HASH-00-SD-BC-RP-0001

BCA ASSESSMENT REPORT

Hurlstone Agricultural High School
(Hawkesbury)

Ref.: 160258

Figure 1: Building 1 Ground Floor Plan

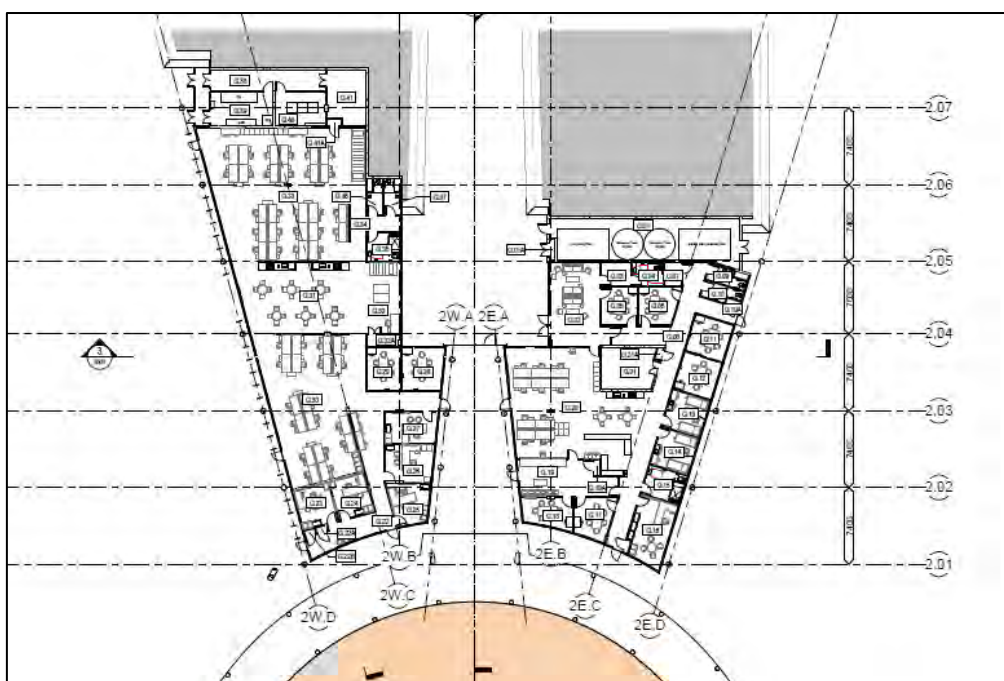
Clause D1.2 (Number of Exits) Building 1 is serviced by the requisite number of exits thereby satisfying the minimum requirements for a Class 5 building.

Clause D1.4/D1.5 (Exit Distances) The travel distances to exits within the proposed building have been assessed as complying with the DTS provisions of the BCA (namely all parts of the floor area within 20m of a point where a choice of alternative exits are available; or no further than 40m to one of those alternative exits; Furthermore, the exits are less than 60m apart when measured back through that point of choice).

Clause D2.20 (Door Swing) The hinged exit doors currently swing in the direction of egress.

Figure 2: Building 3

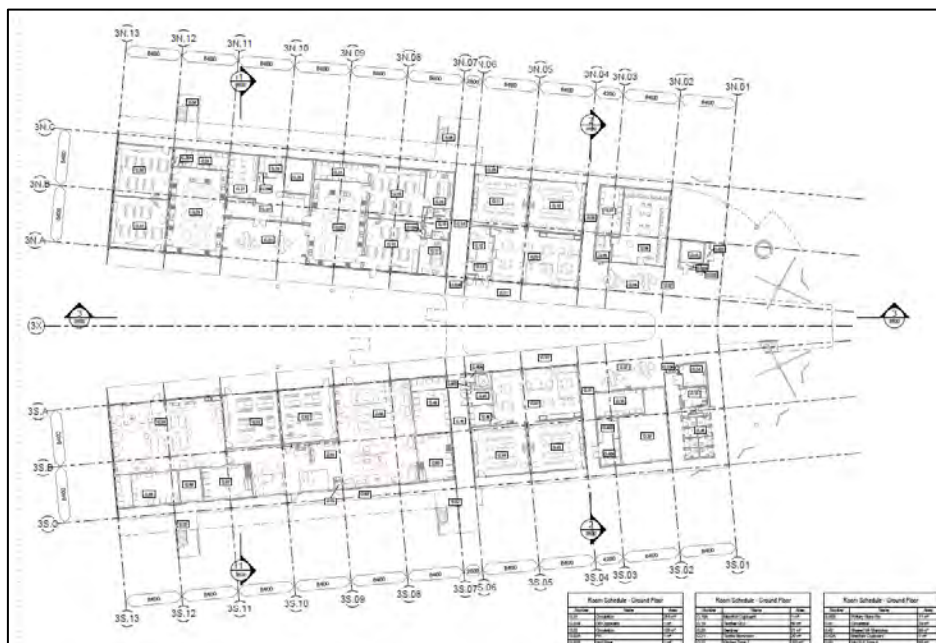
- + Building 2: Complies.
- + Building 3: There is up to 88m (level 2) and 82 m (level 1) measured between alternative exits on Level 1 and Level 2. It is understood that this will be justified in a Fire Engineered Performance Solution due to the open nature of the building and the natural venting within the open balconies and open corridors.

Figure 3: Building 3 'outboard' learning spaces

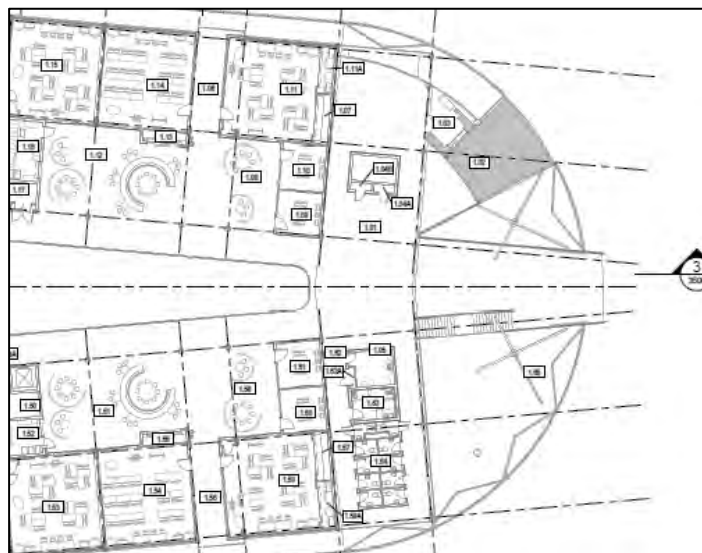
- + In the storey immediately below the roof, *internal* columns need not have an FRL.
- + The floor of the class 9b building is to achieve an FRL of 120/120/120 inclusive of the 'outboard' learning spaces, as seen in Building 3 below.

- + All cladding to external walls will need to be assessed for its ability to comply with BCA Spec C1.1, namely:
 - o Clause 2.4 where the product is proposed as an attachment to a wall;
 - o Non-combustible construction where it forms part of the external wall.

Figure 2: Level 1 Floor Plan

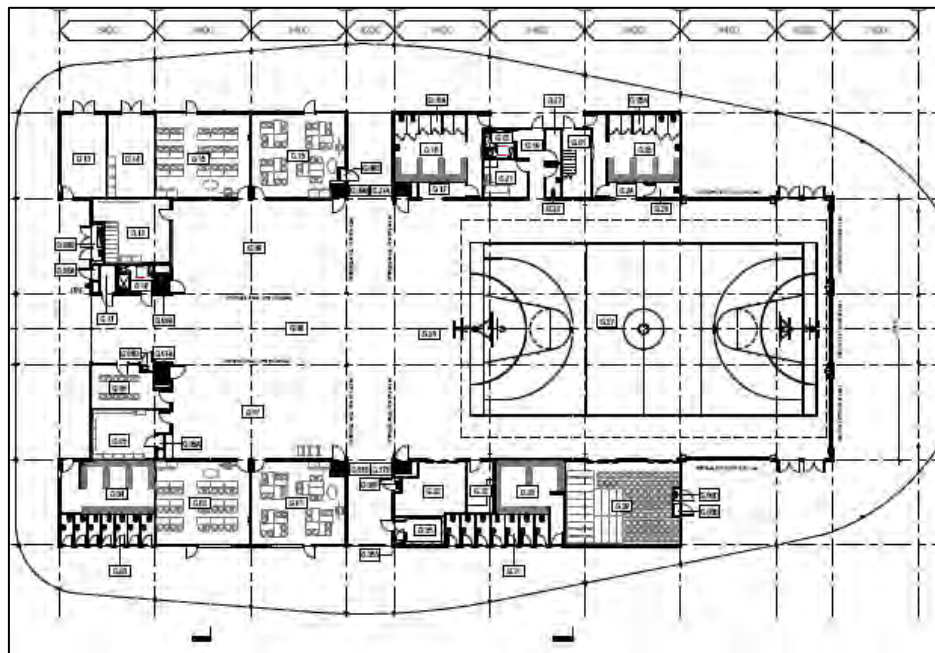
Clause D1.2 (Number of Exits) Each storey within the building must be serviced by a minimum of 2 exits (i.e. each storey in a primary or secondary school with a rise in storeys of 2 or more). In this regard it is noted that the plant room has only a single exit, therefore departing from the requirements of this clause, albeit this is not a habitable space nor is it accessed by staff or students. Accordingly we expect that this will be addressed as a **Fire Engineered Performance Solution** to justify a single exit to the plant room, based on compliance with the distance to exits requirements.
